OPTIONAL SERVICE BULLETIN

NO. OSBD4-048

Installation of additional instrument panel cooling devices.

„I-Panel cooling for severely hot climatic conditions“

| Dimensions in Millimetres | Tolerances are ISO 2768 m | NEXT ASSEMBLY: D4D-9200-00-00 | DRAWING NUMBER: D4D-9221-20-03 |

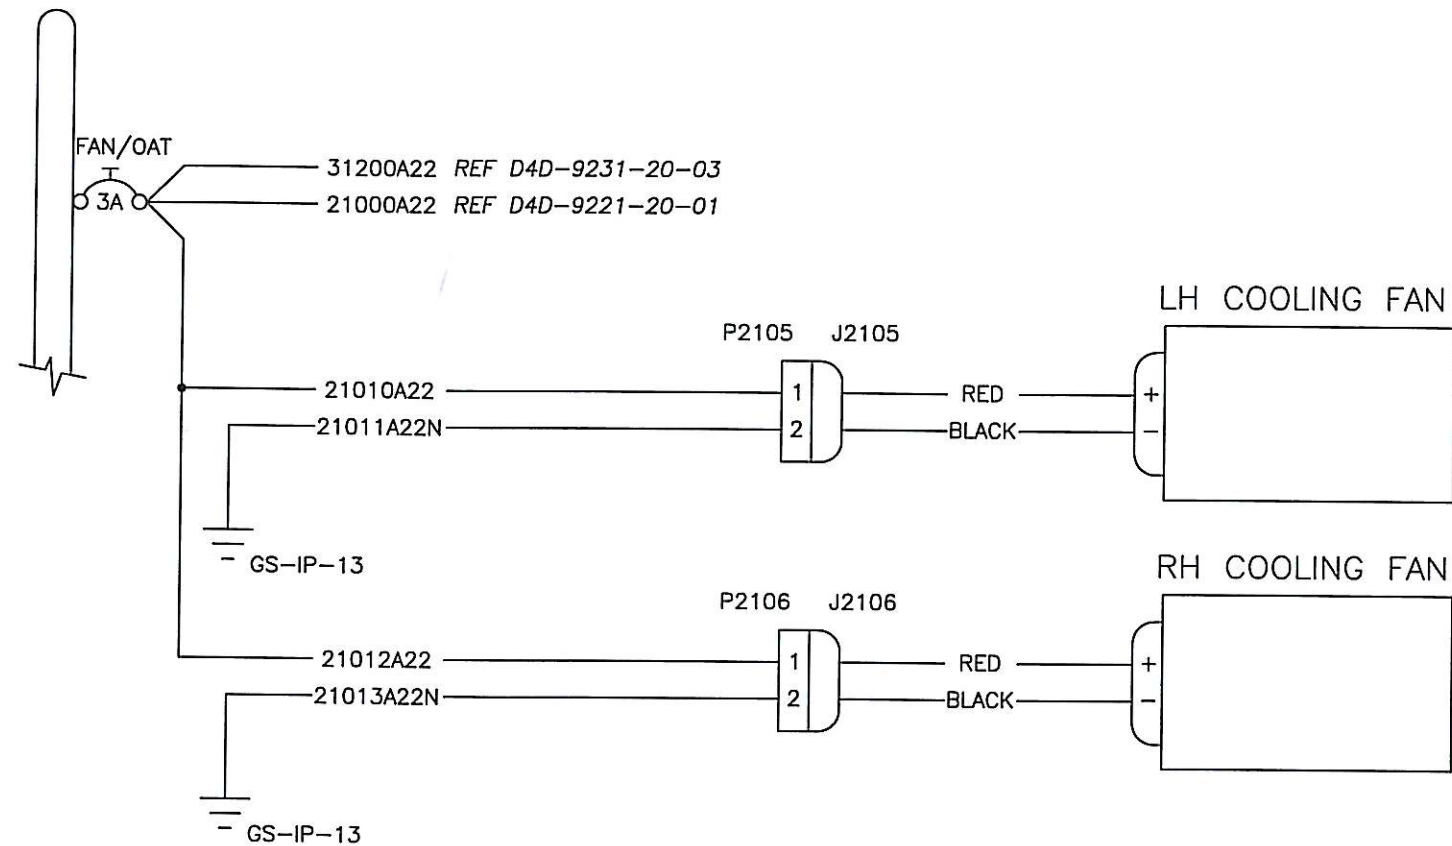
| 6 | Wire the positive leads of the cooling fans to circuit breaker "FAN/OAT" in accordance with drawing D4D-9221-20-03. |
| 7 | Wire the negative leads of the cooling fans to an appropriate ground stud in accordance with drawing D4D-9221-20-03. |

| 2 | 9 | - | D4D-2121-00-99 | MODIFICATION, HOLE PLUG | | DIAMOND |
|---|--------|--------|----------------|---|---|---|
| | | | | <small> Nächster Zusammenbau: DA4-3103-00-00 </small> | <small> Zeichnungs Nr.: DA4-3103-02-00x01 </small> | <small> Blatt 1 1 Bl </small> |

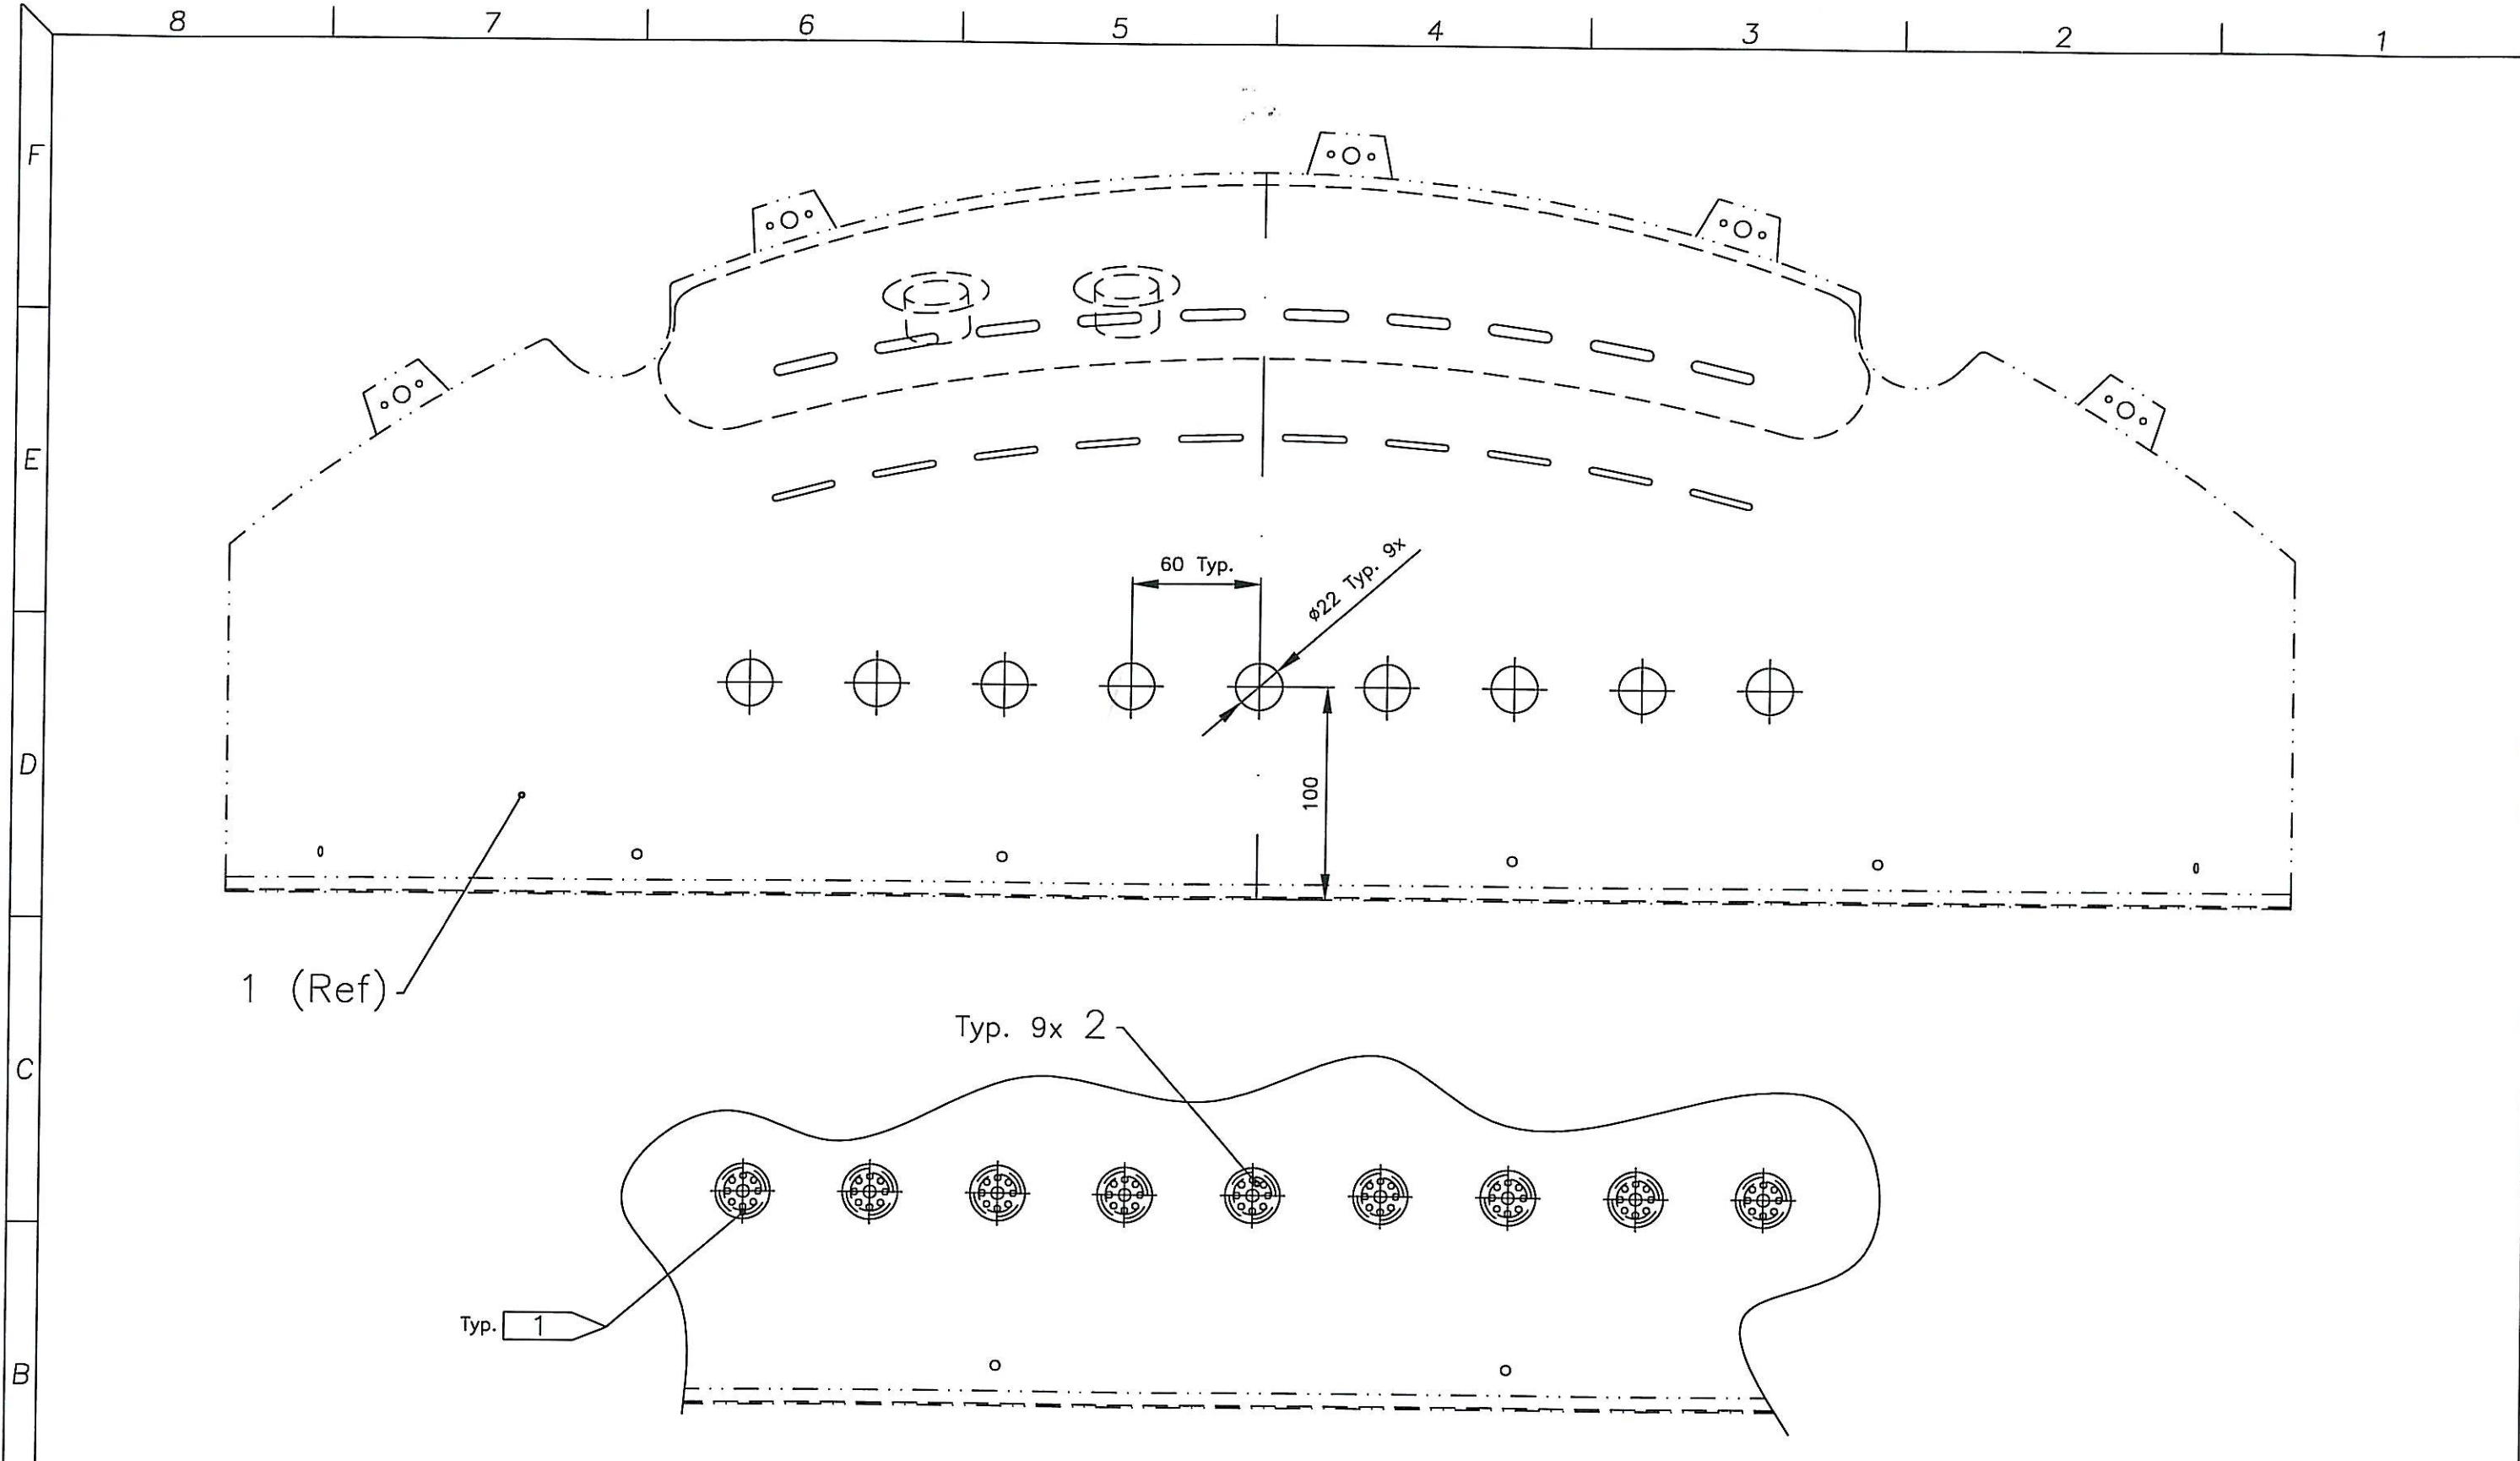
| 2 | Drill the 9 holes (22 mm) into the instrument panel cover in accordance with drawing DA4-3103-02-00x01. |
| 3 | Install the ventilation plugs and secure them with 5-min Epoxy resin. |

1 Bond Item 2 with 5-min Epoxy to inner side of Item 1.
